**CLUTCH PUSH ROD BEARING THRUST WASHERS / 1200CC MOTORCYCLES**

Clutch Push Rod Bearing - Exploded View

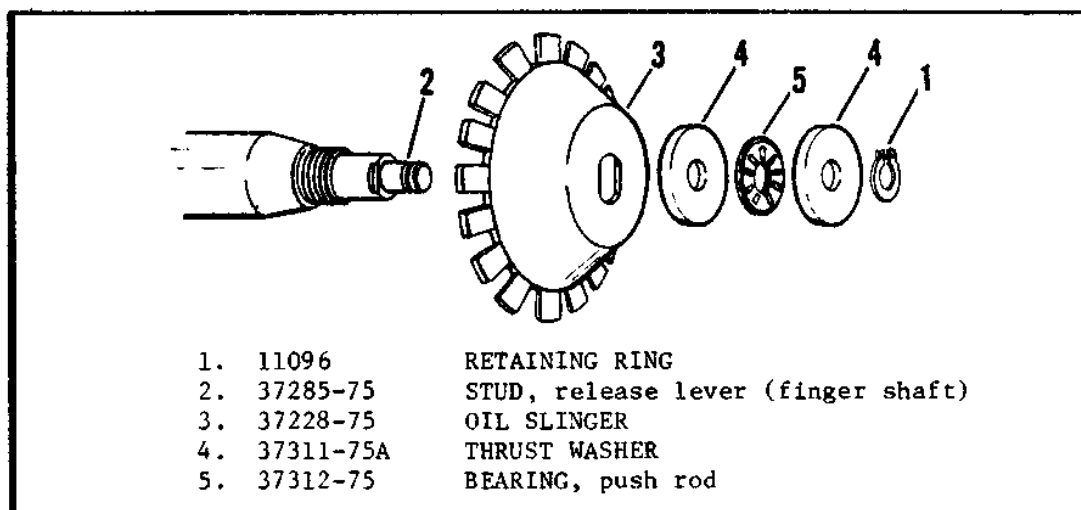
A limited number of FL/FX transmissions were assembled with improperly heat treated thrust washers, part number 37311-75A, in the clutch push rod bearing. (See illustration) The suspect transmissions fall within the number range of W4000 to W6000.

1. Determine whether the motorcycle falls within the appropriate VIN range.
2. Check the transmission number (located on the right front of the transmission housing). If the number is within W4000 and W6000, check for the faulty thrust washers as outlined in Step 3.
3. Remove the transmission filler plug. Using a file or similarly sharp tool, try to scratch the surface of the outer thrust washer. If the surface is scratchable, you must replace both thrust washers. If not, or if the thrust washers are of the earlier style (smaller in diameter), you need not replace any.

If bearing fails due to soft washers, remove washers and bearing and examine clutch push rod and adjusting screw end for excessive wear. Order your parts requirements using part numbers shown below. Credit for damaged parts will be given following normal warranty procedures.
